**1120 John Street**

**Onni Group**

**DRB Recommendation Meeting**

**SDCI Project #3030079**

**DRB #2 Modulation (Current)**

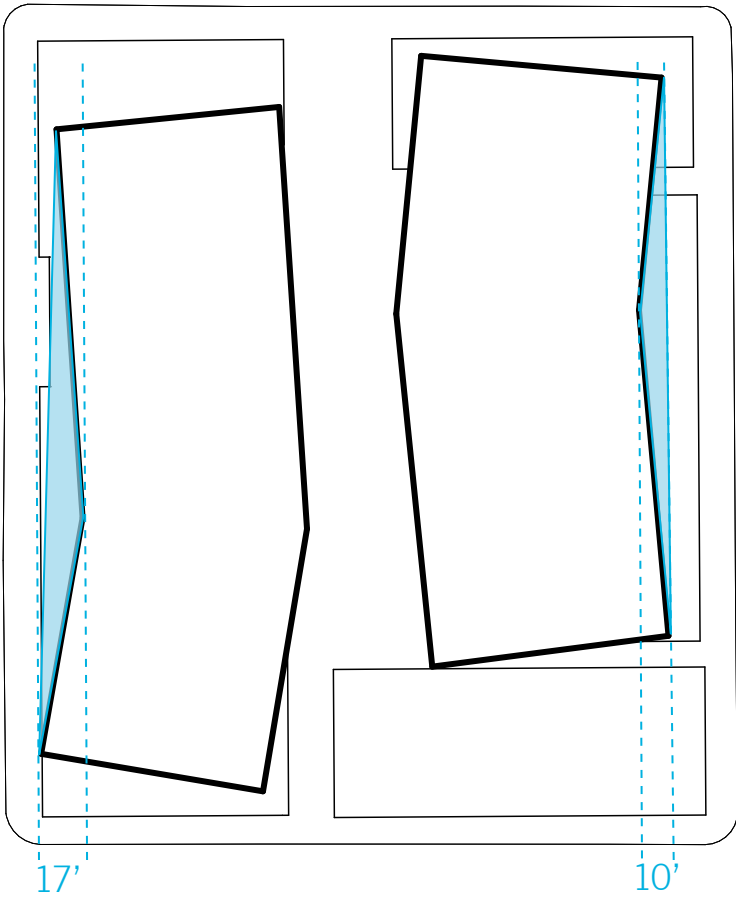
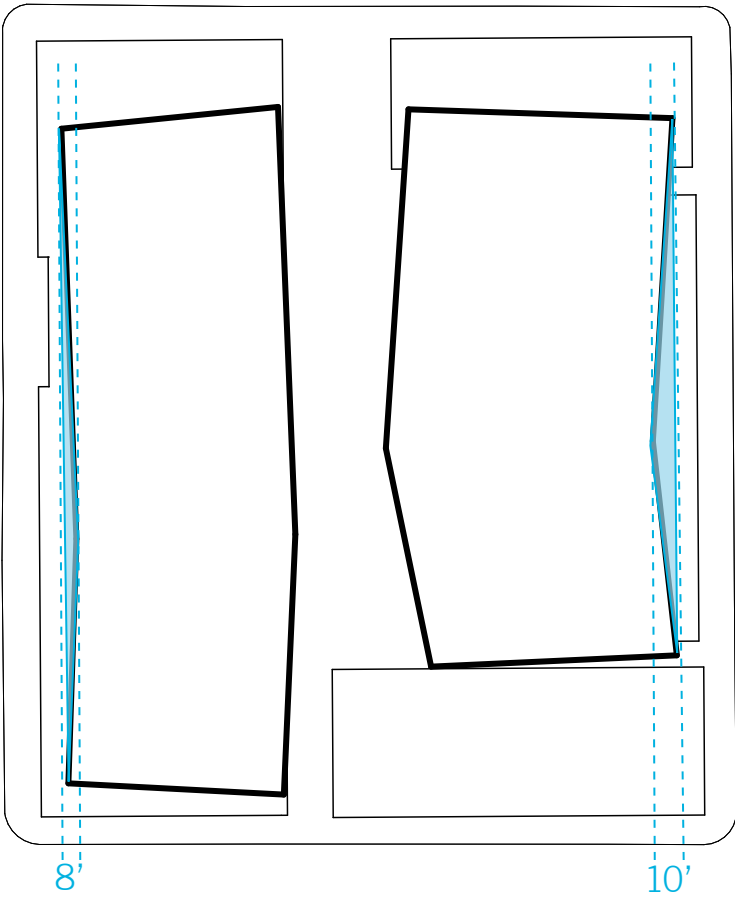
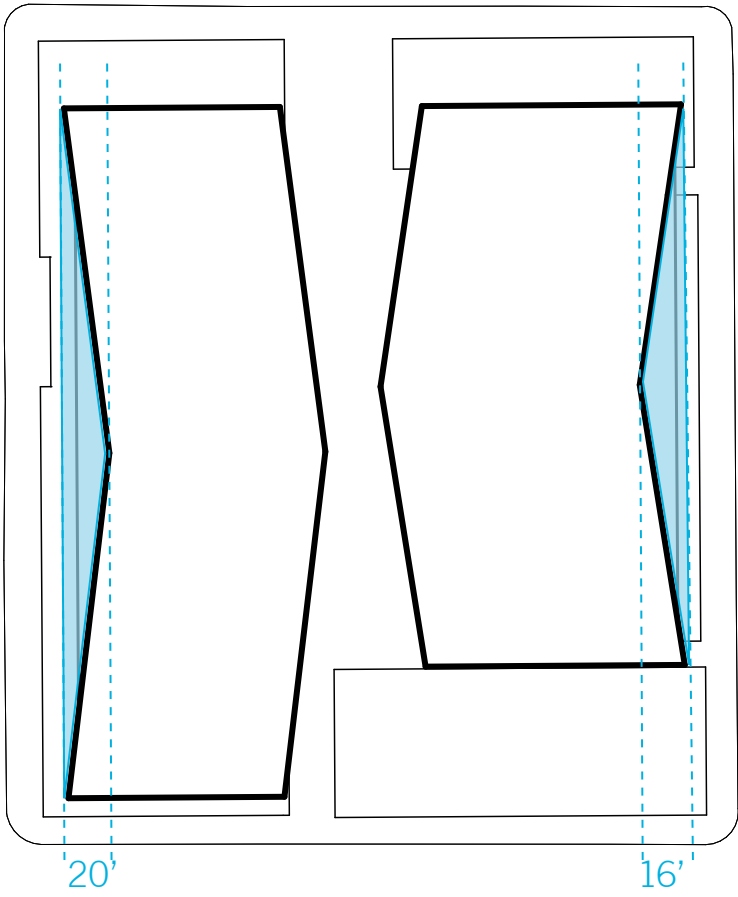
The Board did not support the current design development of the towers, finding the amount of modulation provided by the folded planes inadequate to break down the scale and the mass of the towers. (CS2-4-b)

The design team analyzed an appropriate depth of modulation along Fairview and Boren and in the through block open area between the towers. Along Fairview and Boren, the initial EDG design had a depth of modulation of 15’-0” away from the site setbacks along Fairview and Boren while the DRB #1 depth of modulation was 10’-0” away from the site setbacks. The revised façades along Fairview and Boren now have a depth of 20’-0” away from the site setbacks on Boren and 16’ on Fairview to dramatically increase the overall modulation in accordance to **CS2-4-b.2**.

DRB #1 Overall View from John & Fairview

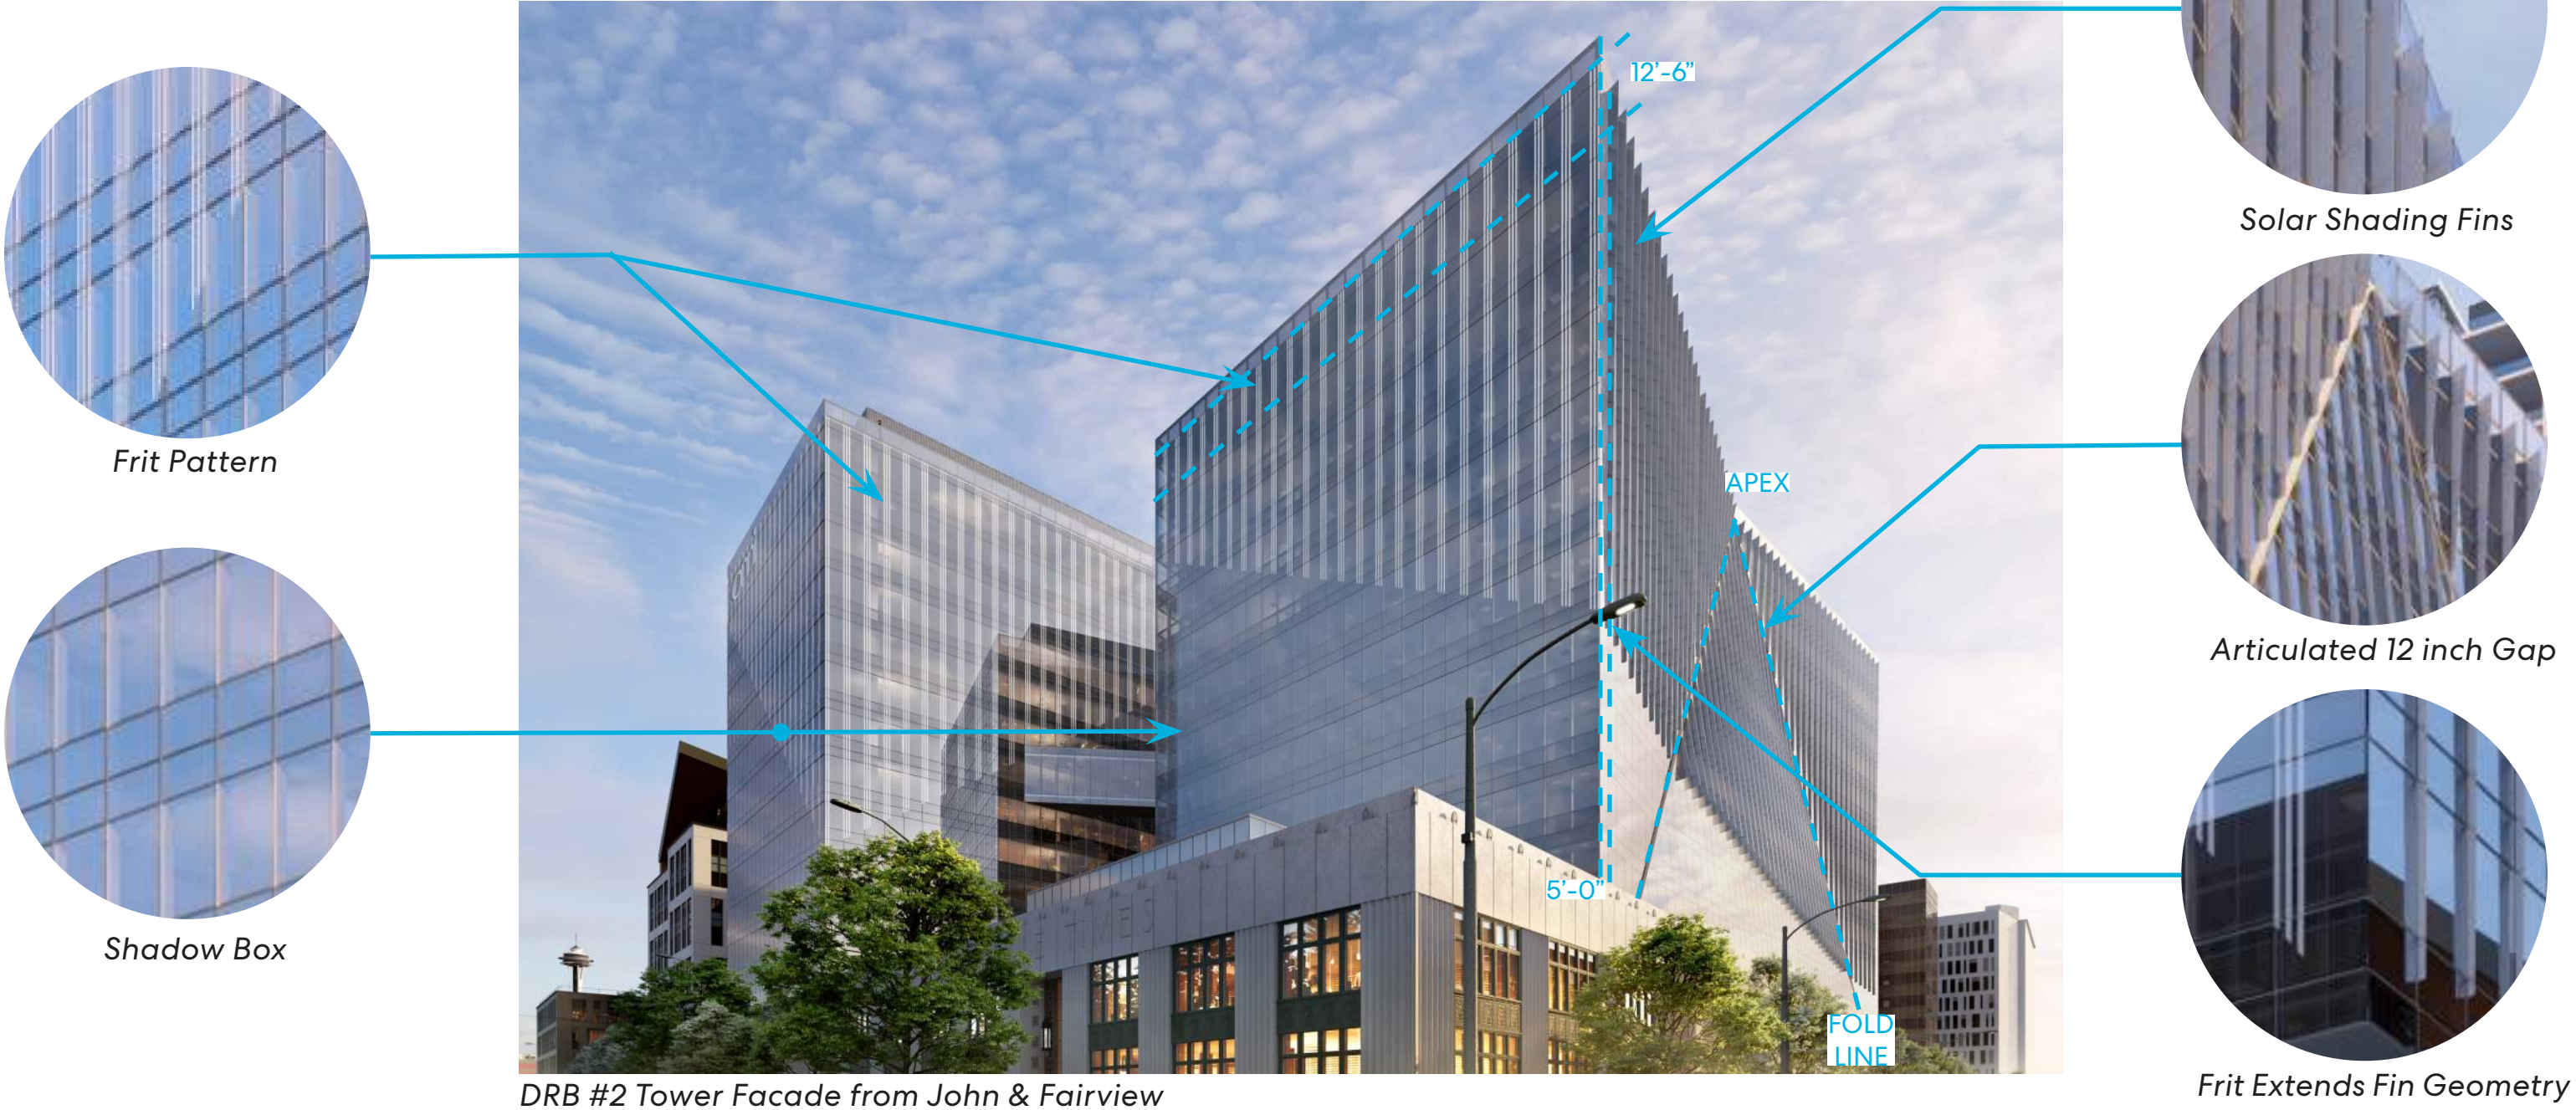
The Board agreed that the components proposed for the tower façades (glazing types and pattern, folded planes, exterior fins) could yield a viable solution, but struggled to see a coherent design concept organizing the components, or demonstration of how this expression was tied to either the existing landmarked structures or the proposed podium elements. (DC2)

1. Vertical frit has been redesigned to work in tandem with the vertical fins to break up the facade and emphasize the folds.
2. Articulated 12” gap added to emphasize fold.
3. Solar shading fins are now vertical with a taper towards the fold.
4. Tower depth has been increased improving the fold at the facade.

The design simplifies the folds (from four to three), frit (triangular to vertical stripes) and fins (angled to vertical) to achieve maximum cohesion and modulation. A single apex point centers within the length of east tower. A 5'-0" vertical grid, based on an abstracted rhythm of the Seattle Times façade, drapes onto the tower façade. A 12'-6" horizontal grid intersects and two fold lines angle down incrementally via the 10'-0" grid to the tower base. Vertical Solar fins create a lacey layer of depth and solar protection where needed and a translucent glass frit pattern breaks down the tower facades into. Although larger in scale, the west tower follows the precedent of the east tower patterning and the prominence of its host, the Seattle Times. The regularized patterning draws inspiration from the practical Seattle Times, while the uniqueness of the vast folding planes float above the ground.
